Comments to ILC coupler designs

Eric Montesinos - CERN

Fuze meeting - 23 August 2013

Two windows

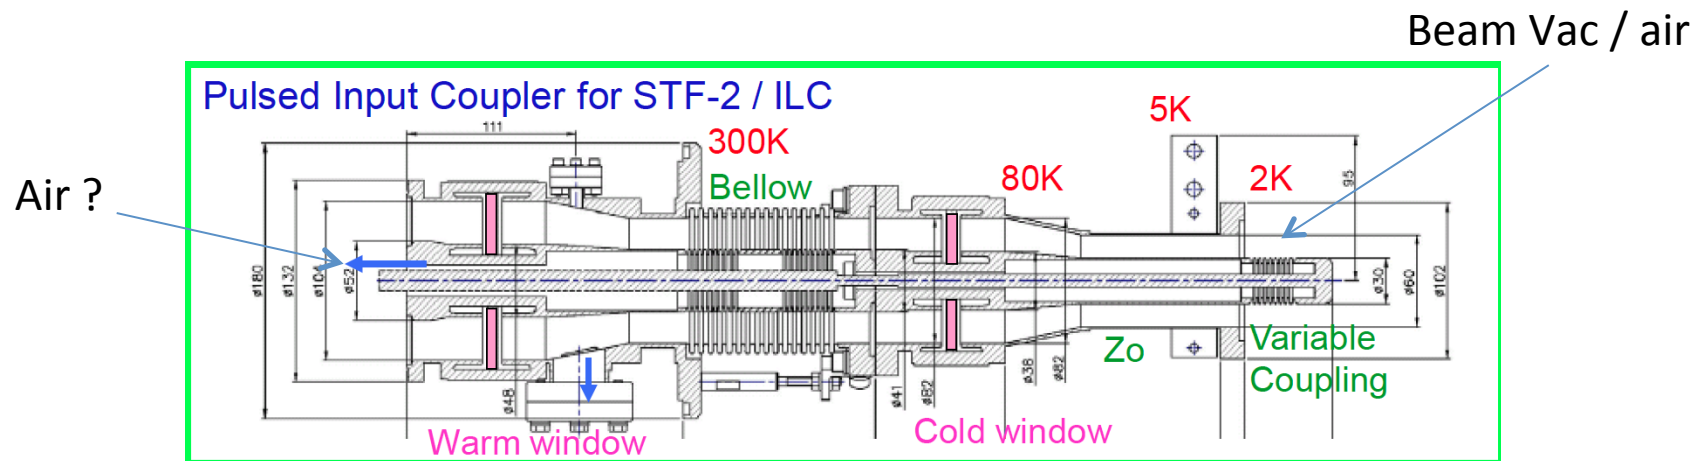
- Over ~ 250 LEP II coupler, after two years of operation, 1 window failure
- Not a major event, only cavity de-rating
- 16,000 couplers \rightarrow 2 windows design mandatory
 - $16,000/250 \times 1$ event per 2 years = 32 events per year

SPL design:

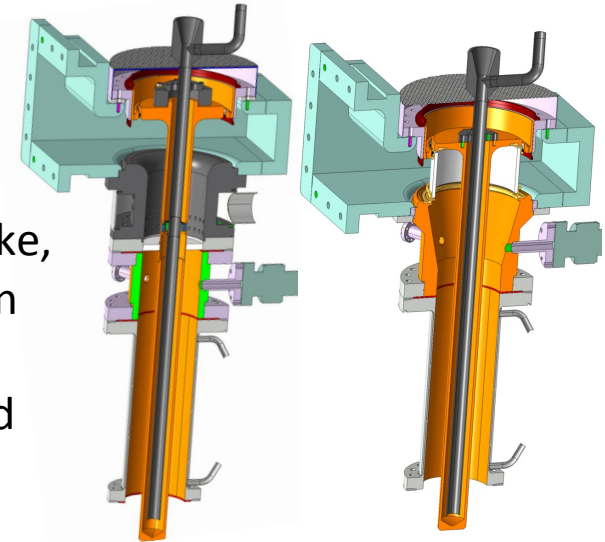
- disk window seen by the beam (no choke, Ti sputtering in contact with both inner and outer)
- Cylindrical window not seen by the beam

Toshiba disk design:

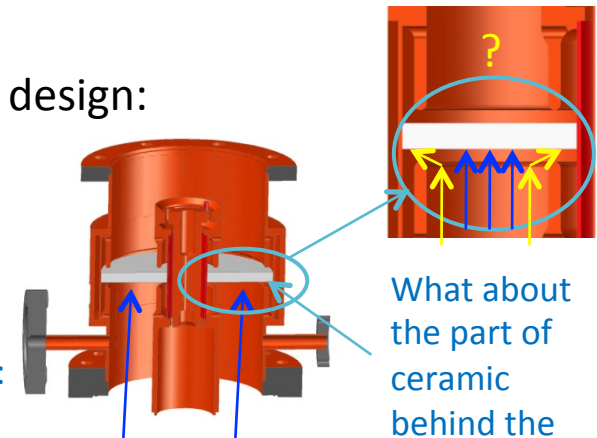
One coating:
 $R = 2 \text{ M}\Omega$

What about the part of ceramic behind the choke ?
